# Access Compliance Report

## Public Rights-of-Way

Intersection ID: 10033070	Main Street: NORTH_COMMUNITY_HOUSE_RD	Cross Street: N/A	Location: NW
ADA ID: E6B9FFF9640B	Ramp Type: PerpDiag	Initial Pass/Fail: Fail	Overall Compliance: No
		Severity Score: 10

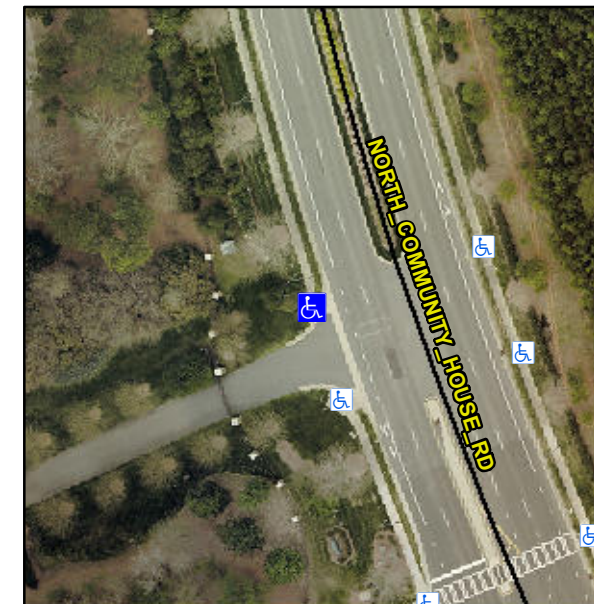
**Not Found, R304.5.1, R304.5.3**

Compliance	Description	Data	Compliance	Description	Data
N/A	Ramp Length (in)	48.0	Yes	Ramp Slope (%)	5.9
No	Ramp Width (in)	41.5	No	Ramp XSlope (%)	4.6
N/A	Flare Type LT	N/A	N/A	Flare Type RT	N/A
N/A	Flare Slope LT (%)	N/A	N/A	Flare Slope RT (%)	N/A
N/A	Flare Traversable LT?	N/A	N/A	Flare Traversable RT?	N/A
N/A	Landing Length (in)	N/A	N/A	DWS Provided?	N/A
N/A	Landing Width (in)	N/A	N/A	DWS Contrast?	N/A
N/A	Landing Slope (%)	N/A	N/A	DWS Length (in)	N/A
N/A	Landing X Slope (%)	N/A	N/A	DWS Full Width?	N/A
N/A	Landing Curb? (Y/N)	N/A	N/A	DWS Offset (in)	N/A
N/A	Shared Landing?	N/A			
N/A	Gutter Ponding?	N/A	N/A	Gutter Slope (%)	N/A
N/A	Gutter Lip Ht (in)	N/A	N/A	Gutter X Slope (%)	N/A
N/A	Painted X Walk1?	No	N/A	Painted X Walk2?	No
	X Walk 1 Direction	To SE		X Walk 2 Direction	To NE
N/A	X Walk 1 Width (in)	N/A	N/A	X Walk 2 Width (in)	N/A
	X Walk 1 Slope (%)	1.6		X Walk 2 Slope (%)	5.3
	X Walk 1 X Slope (%)	0.0		X Walk 2 X Slope (%)	1.7

**Remove & Replace Curb Ramp With Two New Directional Ramps or Equivalent.**
